MILITARY SPECIFICATION

CONNECTOR, ELECTRICAL, RECEPTACLE: 10526125

This amendment forms a part of Military Specification MIL-C-60174(MU), dated 19 March 1965.

FIGURE 1 MECHANICAL GAGE

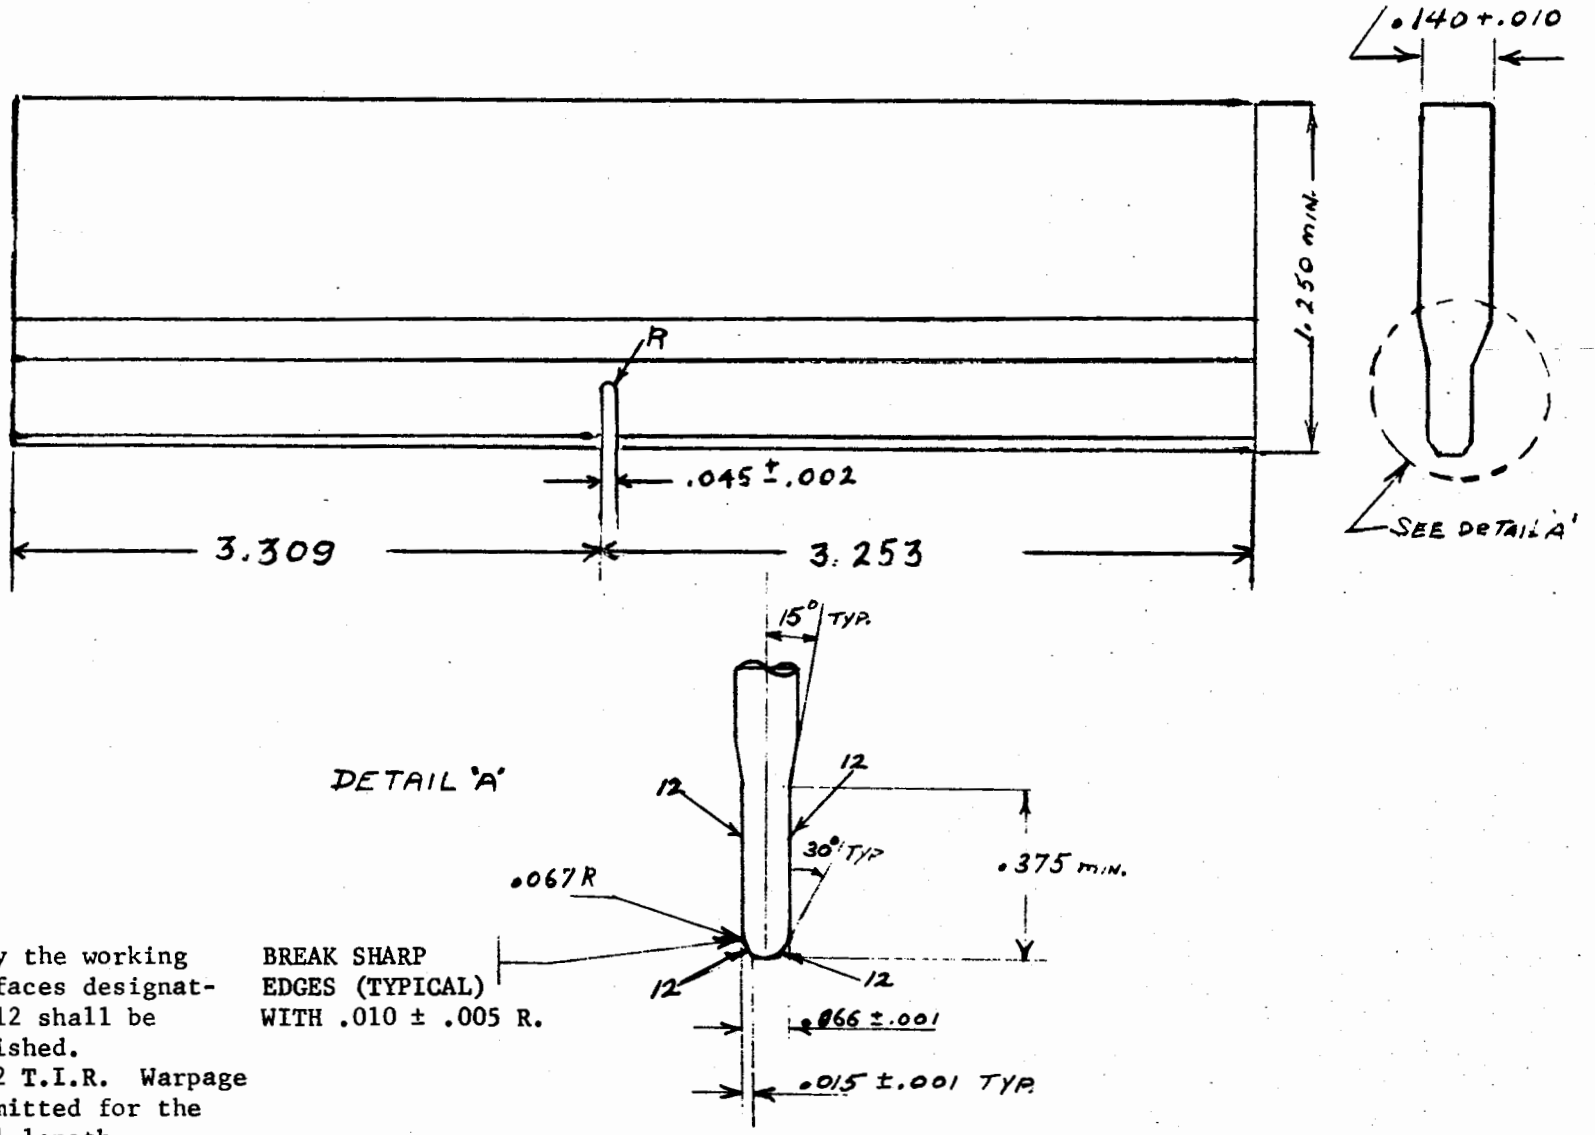
Add "Item 10 Steel gage.- Outline as shown in Figure 1".

Add: Figure 1.
